ADDENDUM

PROJECT TITLE: Landscape Architectural Design Services – King’s Square Pathways and Area Improvements	ADD. NO: 1
RFP NO: 2024-0910015P	DATE: Dec. 19 th , 2024
PAGE 1 of 6 (Including Confirmation Sheet)

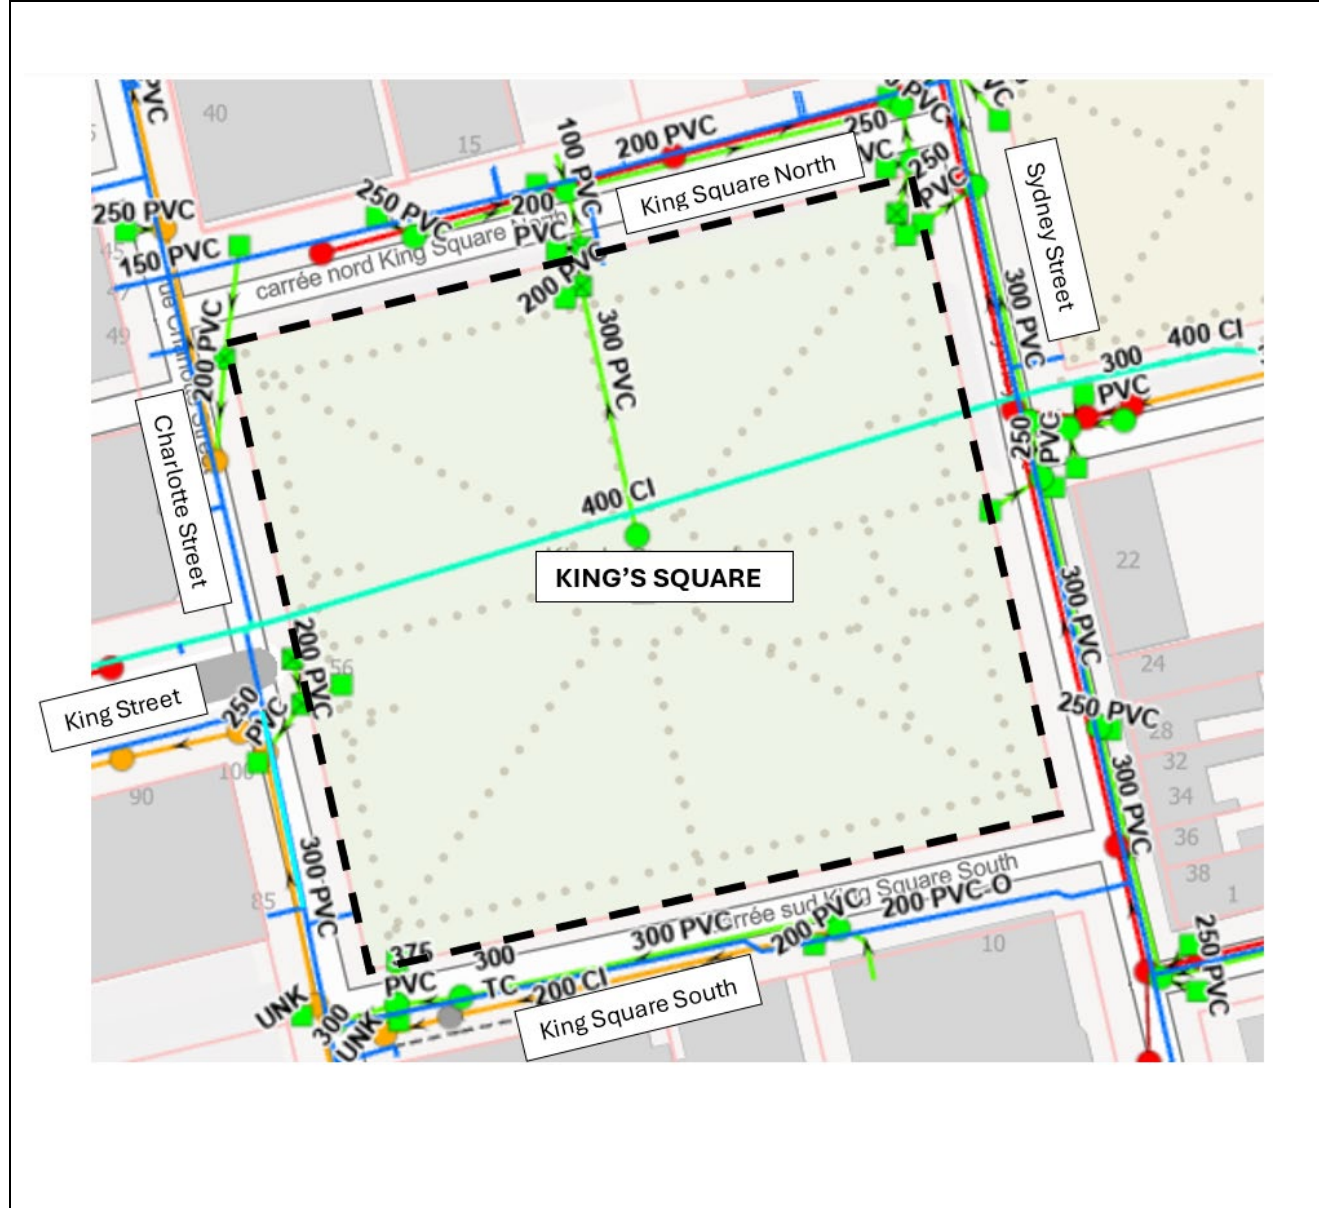
Q2. Should topo and infrastructure surveys include all surrounding streets or be limited within the property lines?

A2. *Below is a snapshot from our GIS to give an overview of the extent of water and sewer infrastructure in King’s Square (bright green is stormwater infrastructure and the teal 400 mm dia pipe is the water transmission main). Further GIS information will be available to the successful consultant.*
